Subject: Calvert Cliffs Nuclear Power Plant
Units Nos. 1 & 2, Dockets Nos. 50-317 & 50-318
Auxiliary Feedwater System

Enclosed are elementary wiring diagrams for the Auxiliary Feedwater Initiation Circuit and information on the Feedwater Annunciation Circuit that you requested.

JOB NO 11865	DRAWING NO 1E-79, SH.27B	REV. NO X
DCN NUMBER 1E-79-2024		DATE 9-25-80
PROJECT APPROVAL <i>JMB</i>

JOB NO	DRAWING NO	REV NO
11865	IE-79, SH. 27B	X
DCN NUMBER 1E-79-2024		
CONTINUATION SHEET		
PAGE 2 OF 6

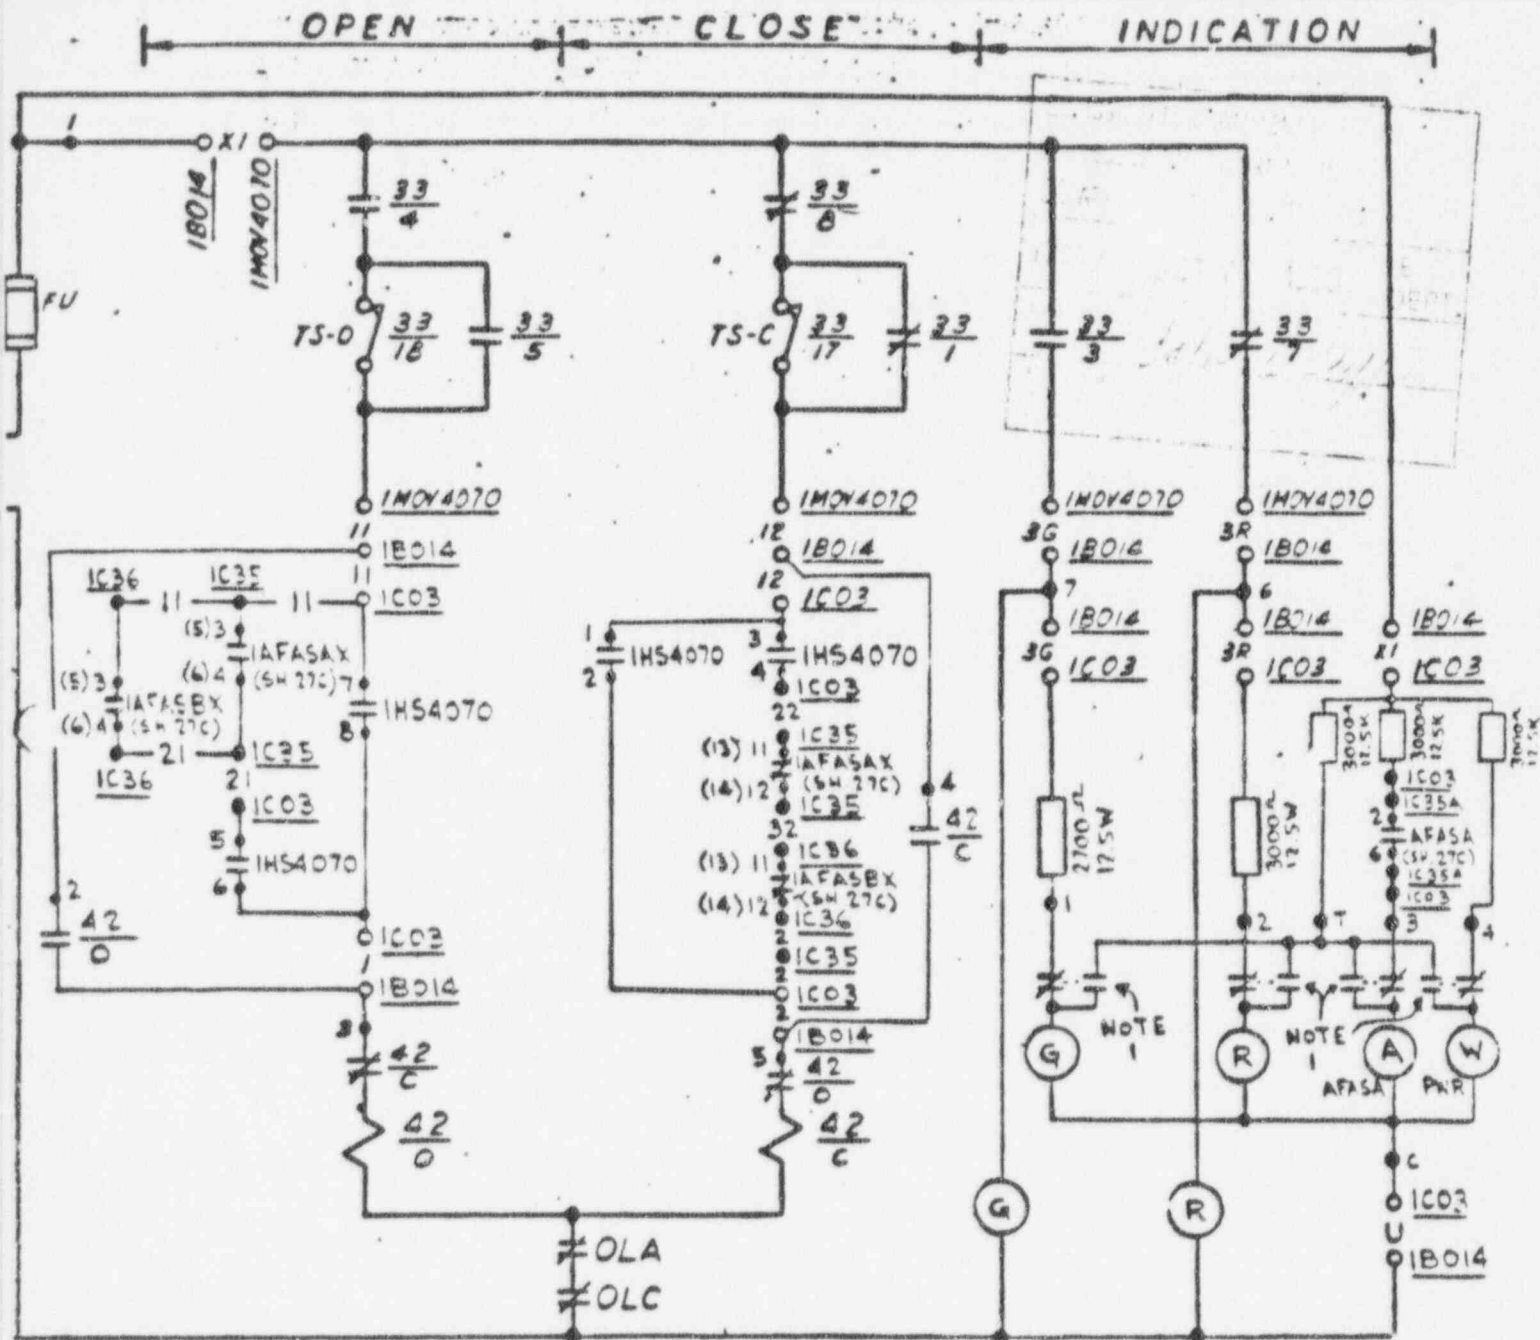
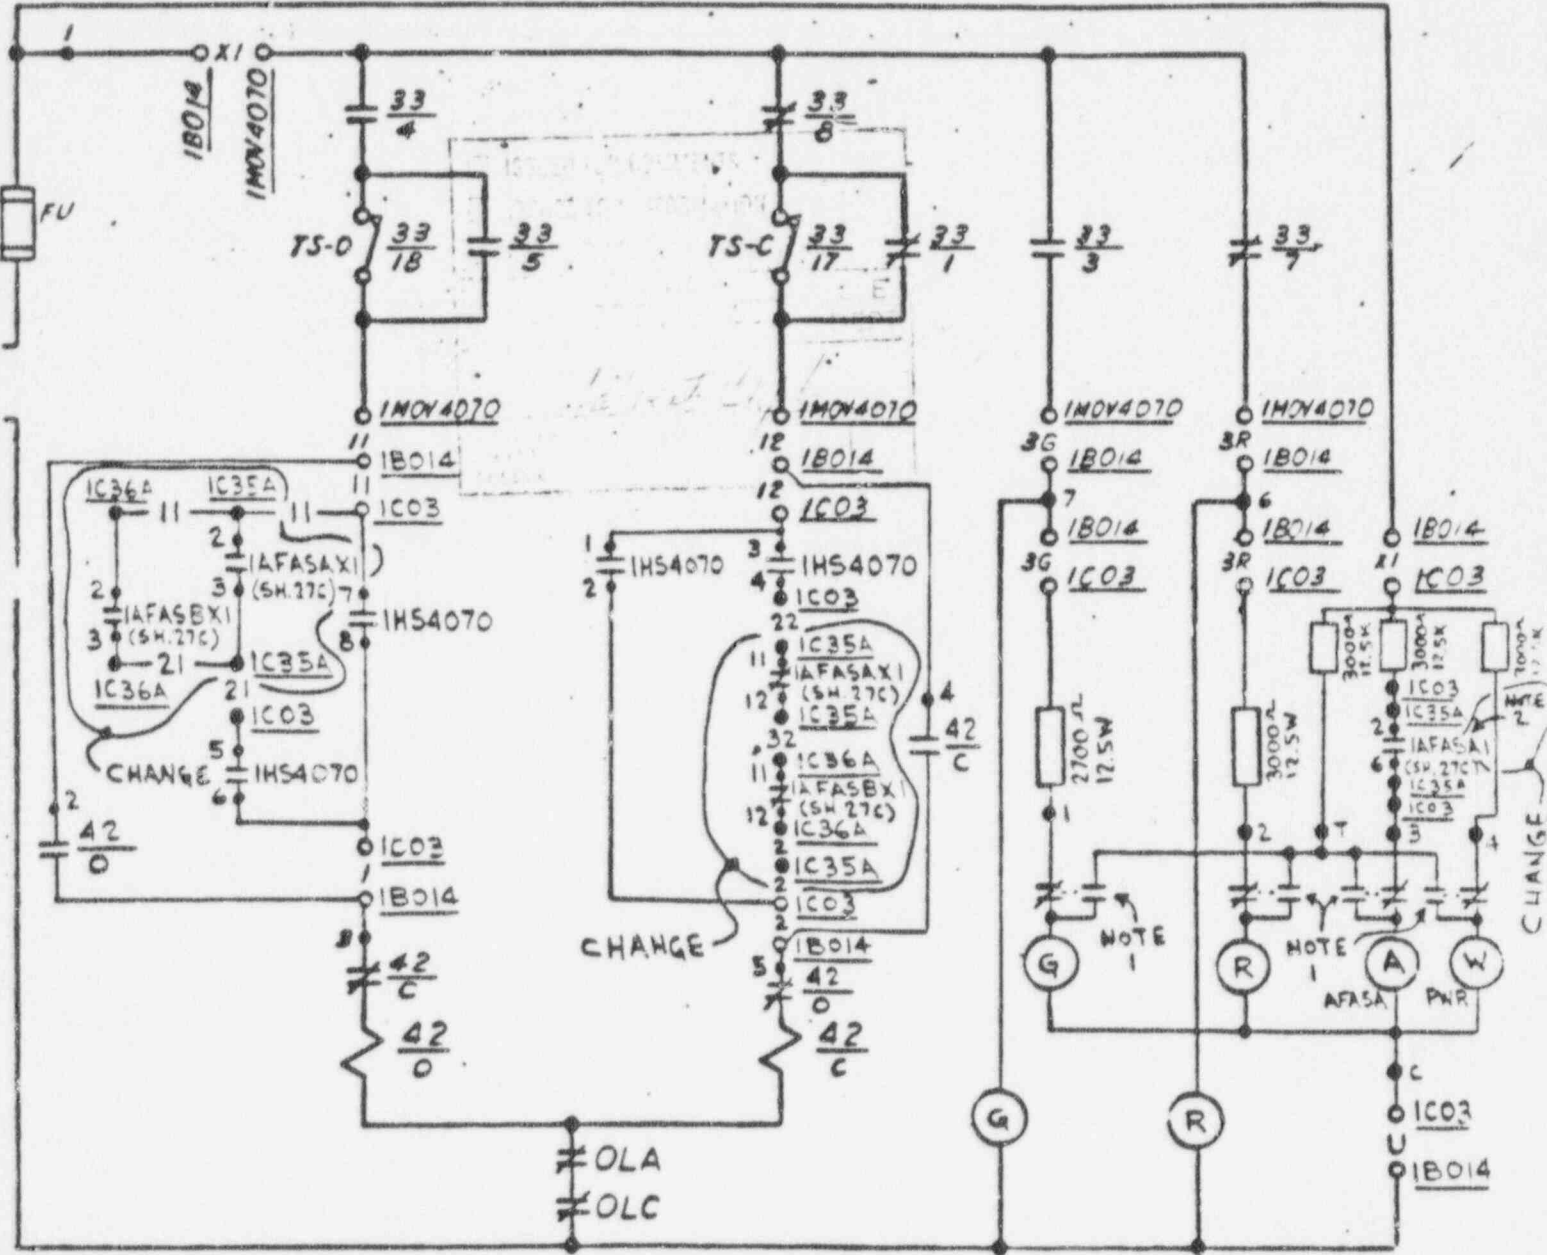
AFTER
SEE PAGE 2 FOR BEFORE

1. PUSHING IN ON LIGHT CHANGES CONTACT STATE
2. CONTACT IAFASAX1 WILL BE IAFASBX1 IN SCHEME 1B0414

JOB NO	DRAWING NO.	REV NO
11865	1E-79 SH.27B	
DCN NUMBER 1E-79-2024		
CONTINUATION SHEET		
PAGE 4 OF 6

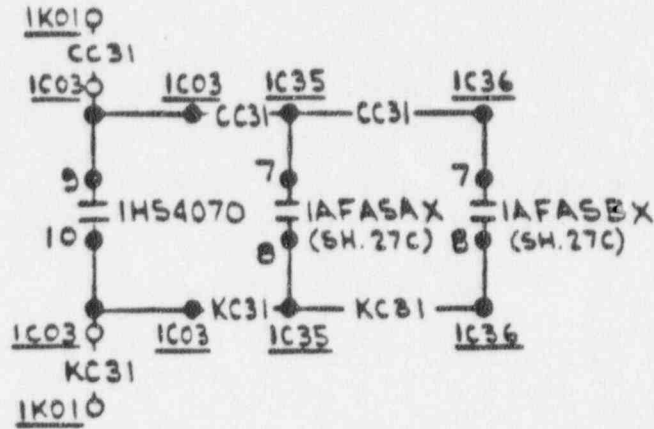
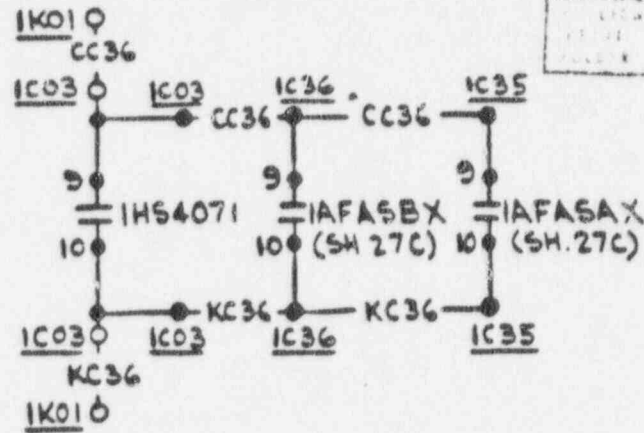
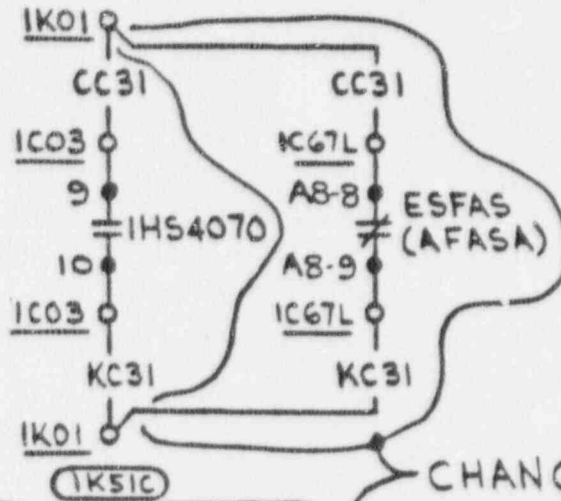
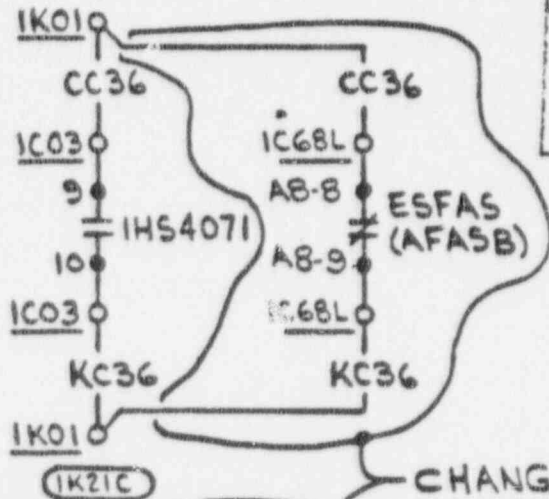
1K51C
AFAS ACTUATION
SYS. A TRIPPED/
I-MOV-4070 BLOCKED

1K21C
AFAS ACTUATION
SYS. B TRIPPED/
I-MOV-4071 BLOCKED

JOB NO	DRAWING NO	REV NO
11865	1E-79, SH.27B	X
DCN NUMBER		
1E-79-22		
CONTINUATION SHEET		
PAGE	2	OF 2

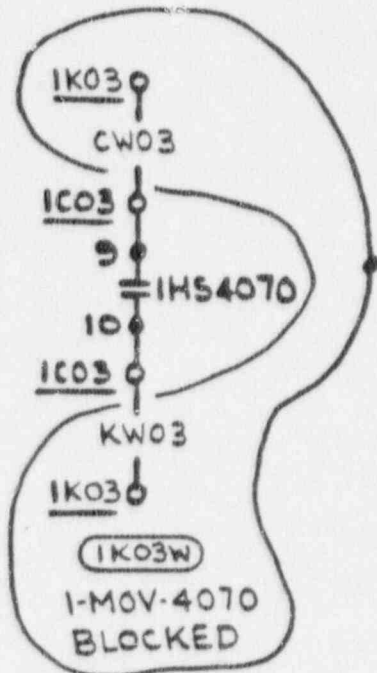
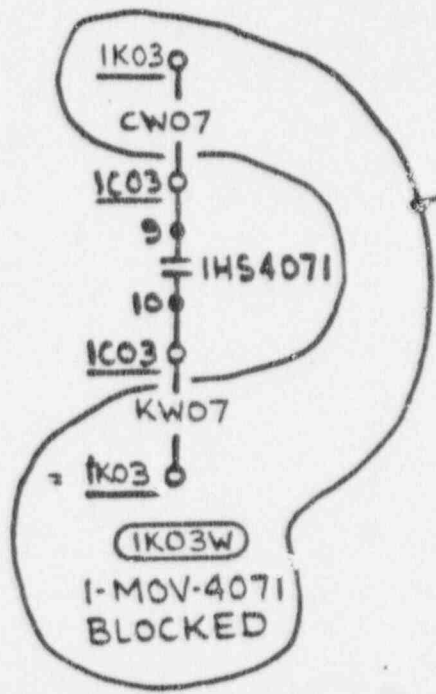
CHANGE

CHANGE

JOB NO. 11865	DRAWING NO. 1-LD-58	REV. NO. X
DCN NUMBER 1-LD-58-2002	DATE 8-5-80	
PROJECT APPROVAL <i>[Signature]</i>

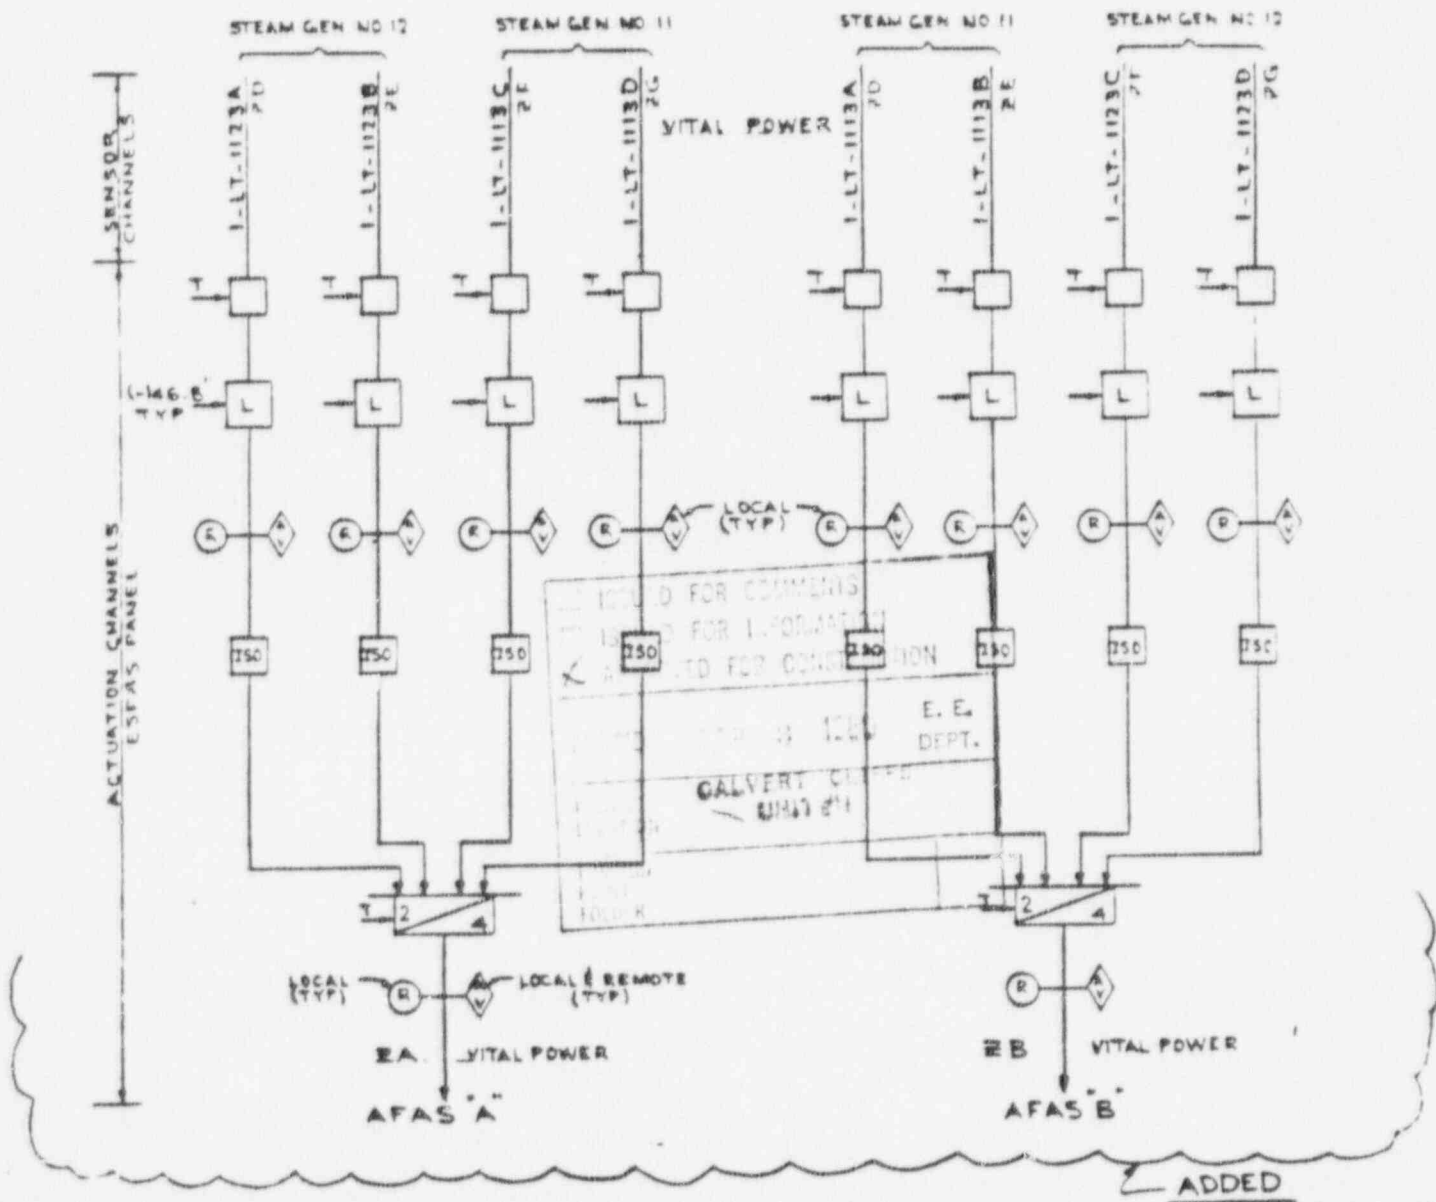
REASON FOR CHANGE: FCR 79-1060 UNIT NO. 1 BG&E DWG. NO. 61-058-E

STEAM GENERATOR LEVEL - AFAS LOGIC
